# DESIGN COMMISSION

**CITY OF MERCER ISLAND  
DESIGN COMMISSION  
STAFF REPORT  
DESIGN REVIEW – EXTERIOR  
MODIFICATION**

**Agenda Item: 1  
March 13, 2019**

Project:	Mercer Island High School Vestibule
Description:	A Design Commission design review for a proposed vestibule at the entrance of the high school, located outside the Town Center.
Applicant:	Brandy Fox of CPM Seattle
Site Addresses:	9100 SE 42 <sup>nd</sup> Street; Identified by King County Tax Parcel # 182405-9005
Zoning District:	Public Institution (PI)
Exhibits:	<ol style="list-style-type: none"><li>1. Plan Set, dated received on January 14, 2019</li><li>2. Project Narrative, dated received on November 29, 2018</li><li>3. Aerial Photo and Materials Information, dated received on January 14, 2019</li><li>4. Development Application, dated received on November 30, 2018</li></ol>

**B1 EAST ELEVATION - ENTRY**  
 1/8" = 1'-0"

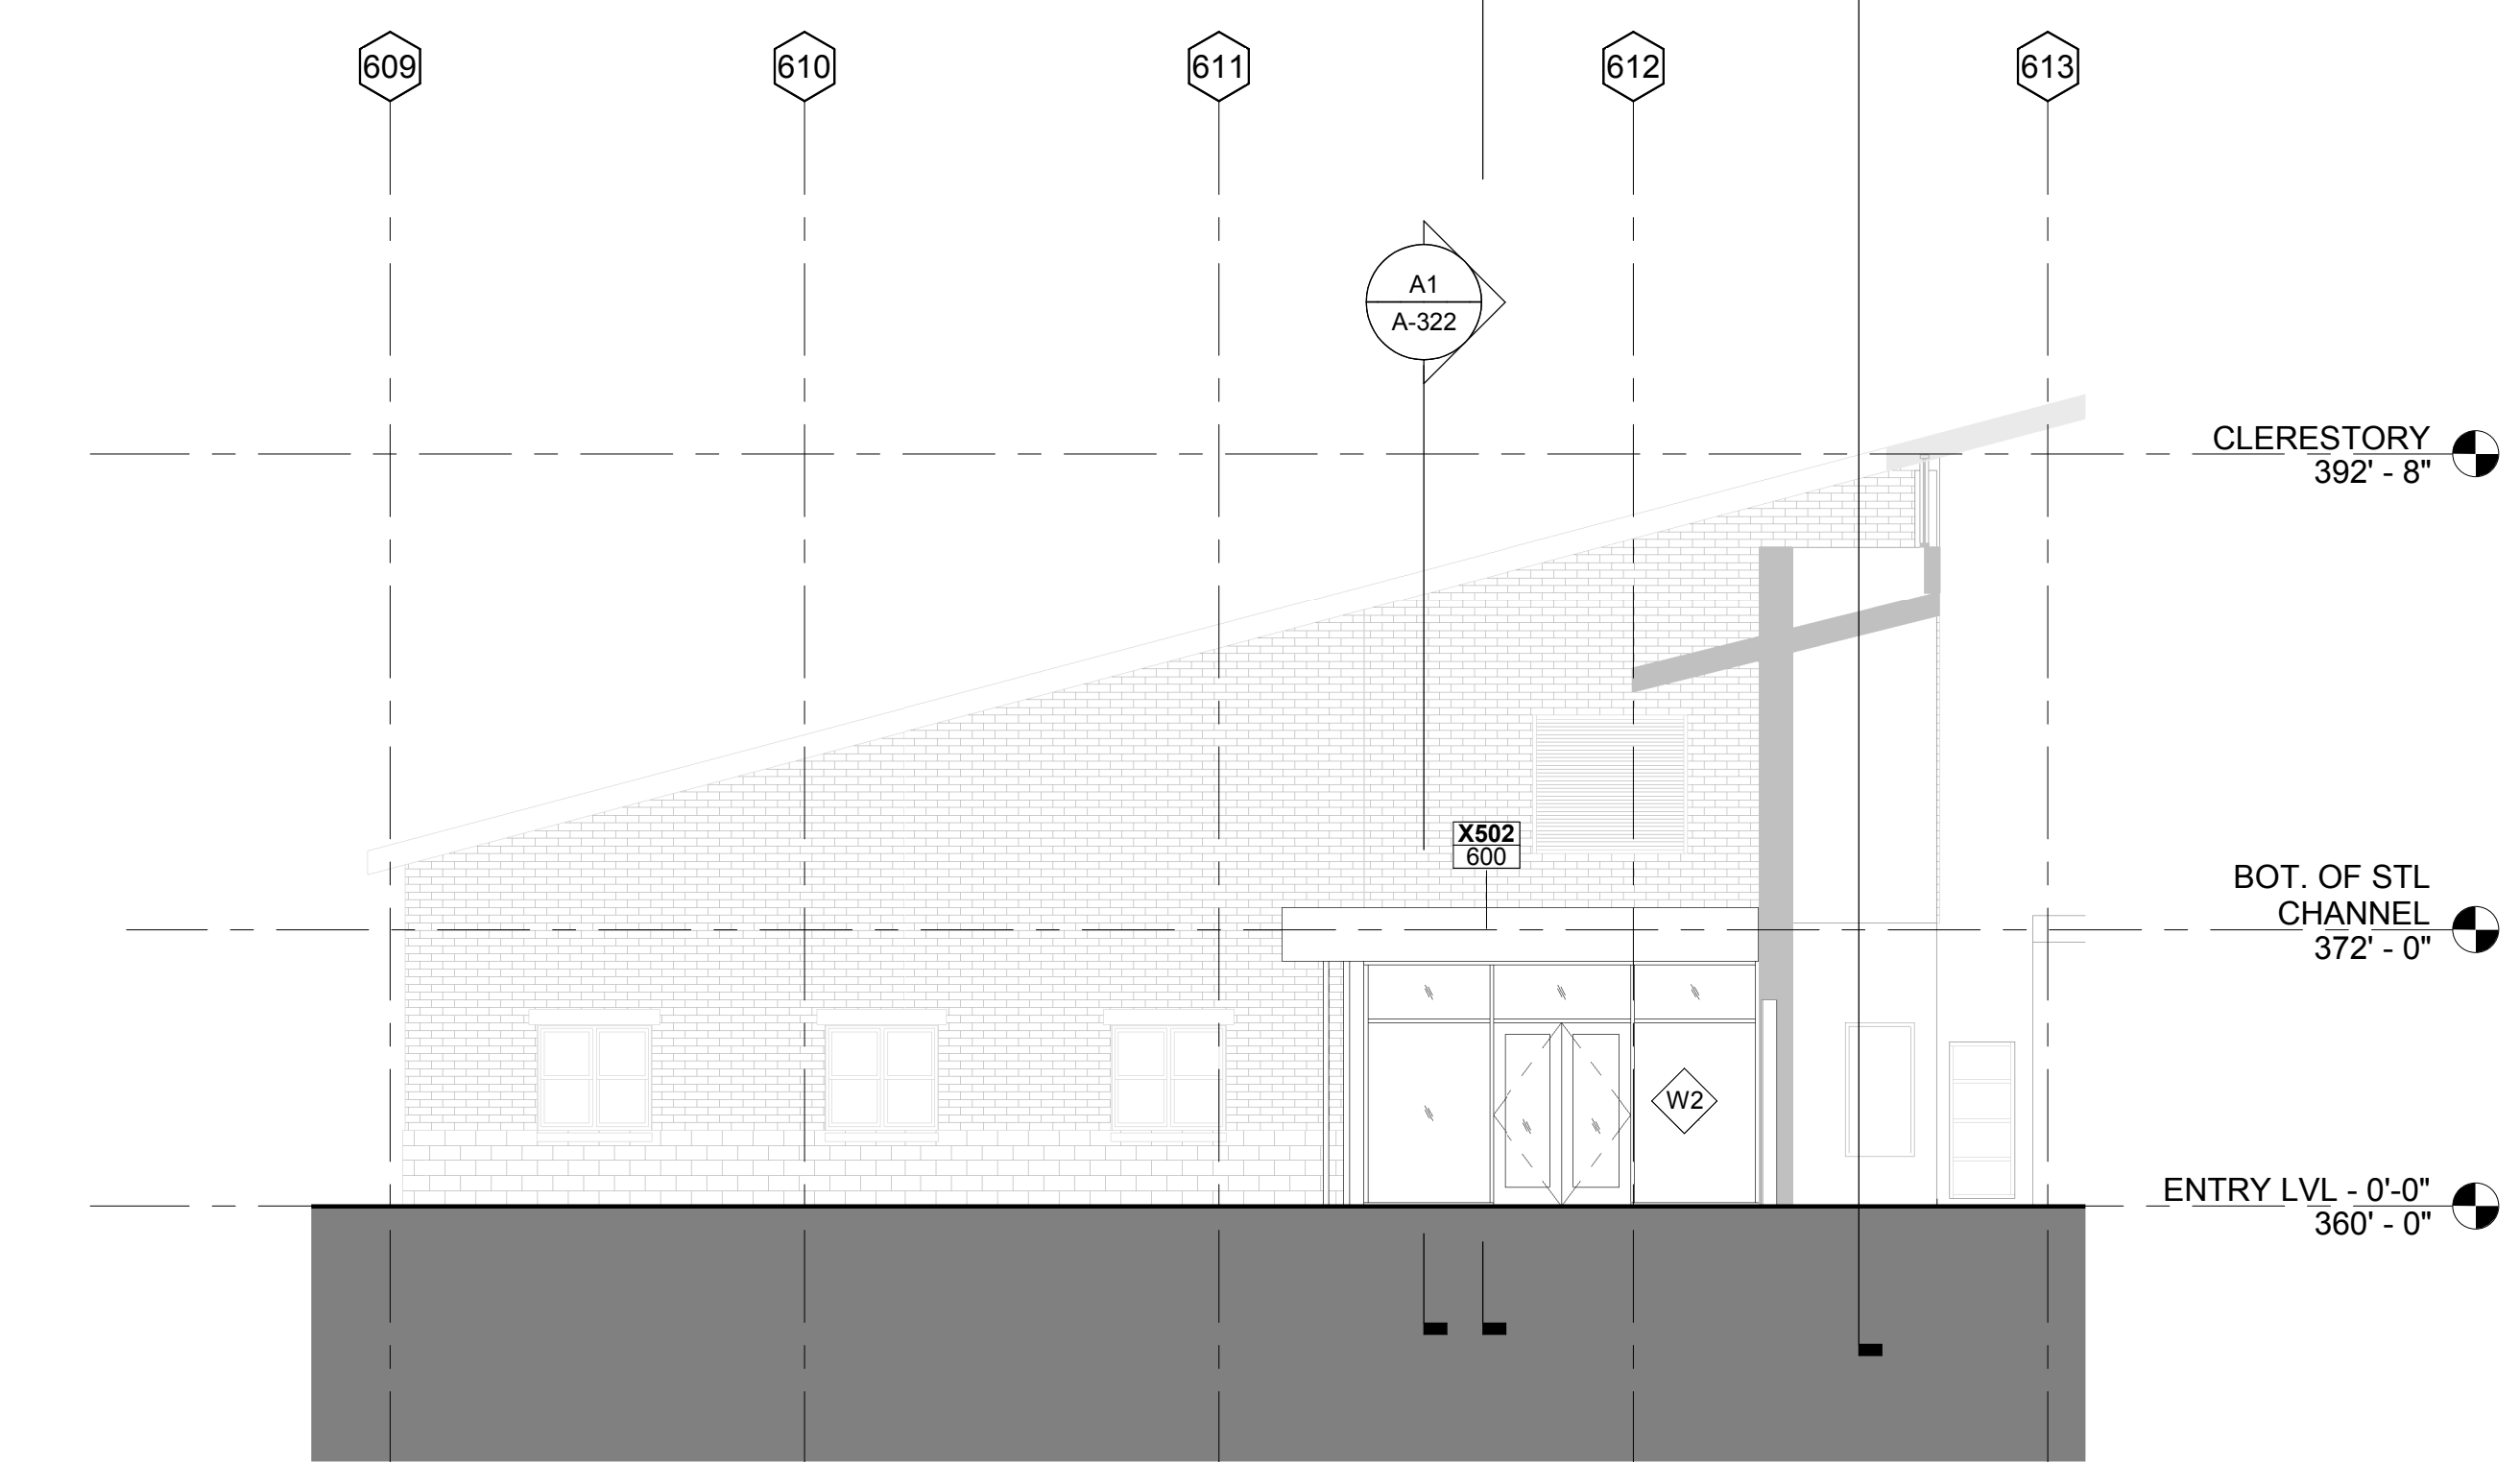
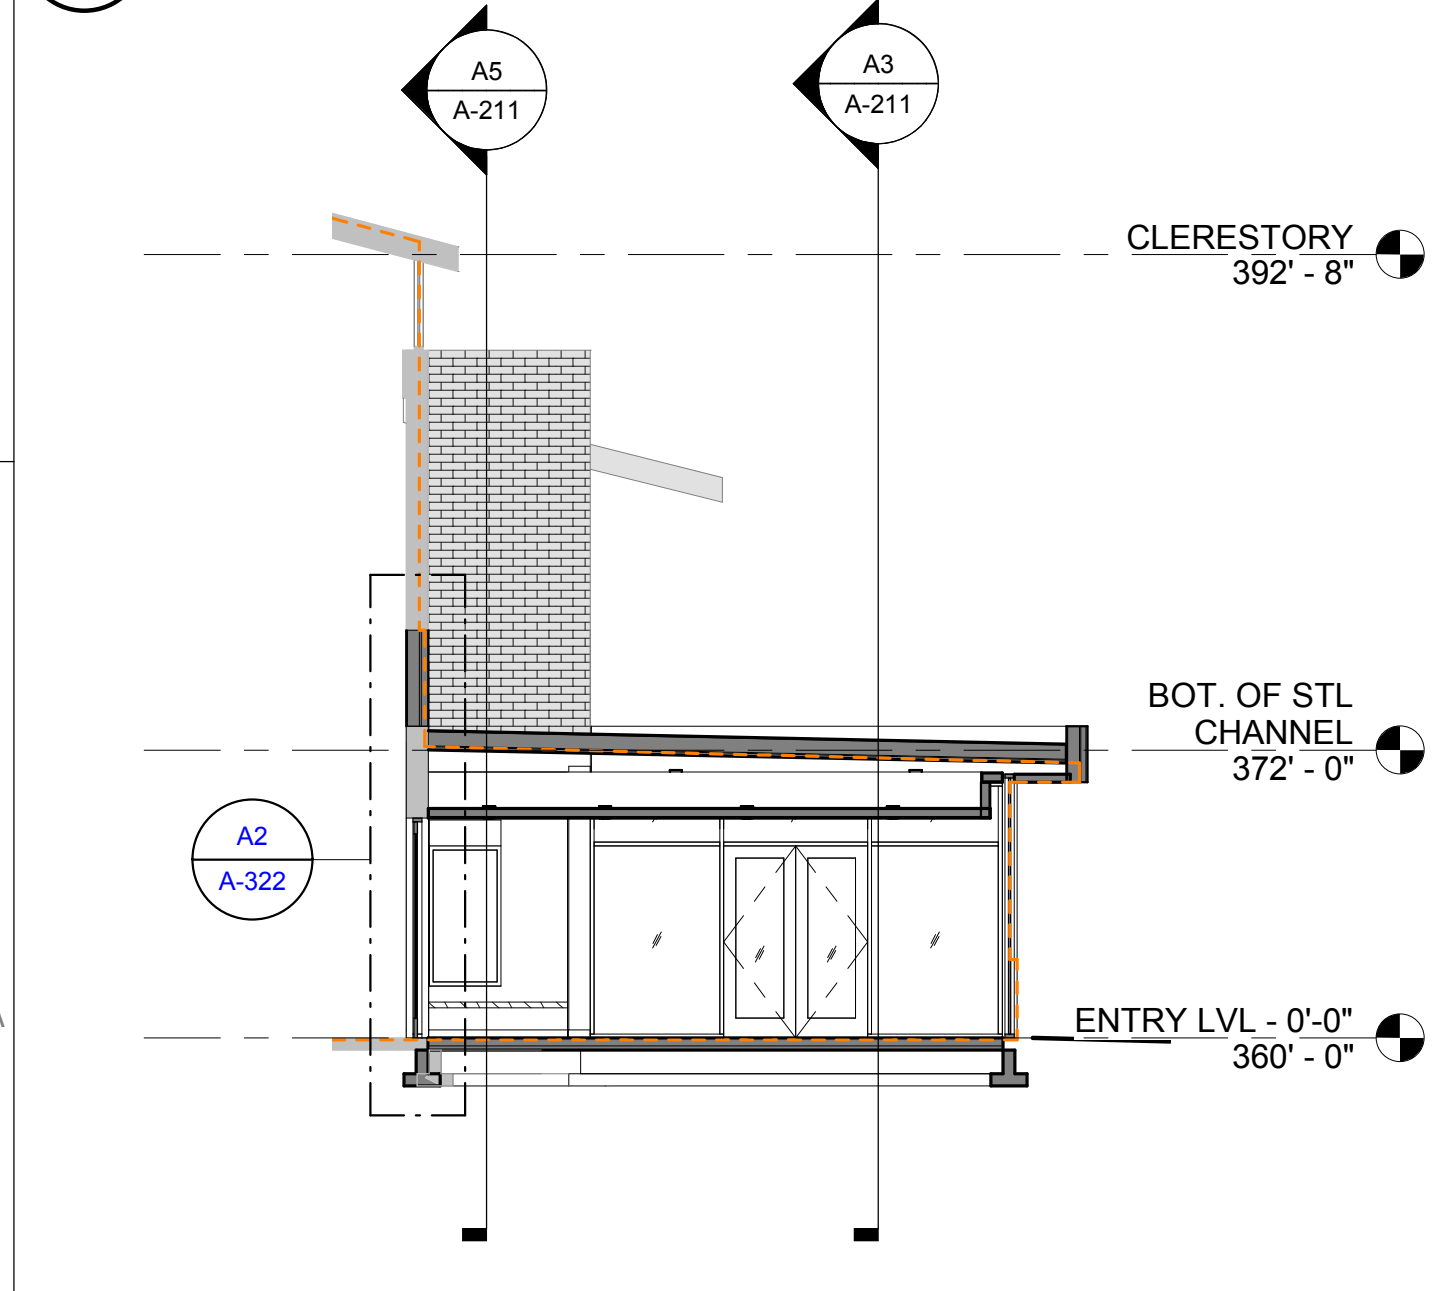
**As shown in Exhibits 1 and 3, the proposed materials and colors are consistent on all facades of the proposed addition and are consistent with the existing building.**

**Concrete blocks are included in the list of materials, however they are not included in the latest iteration of the vestibule's design. Exhibit 3 shows that the concrete blocks would be both textured and smoothed to add variation to any façade that would use the blocks.**
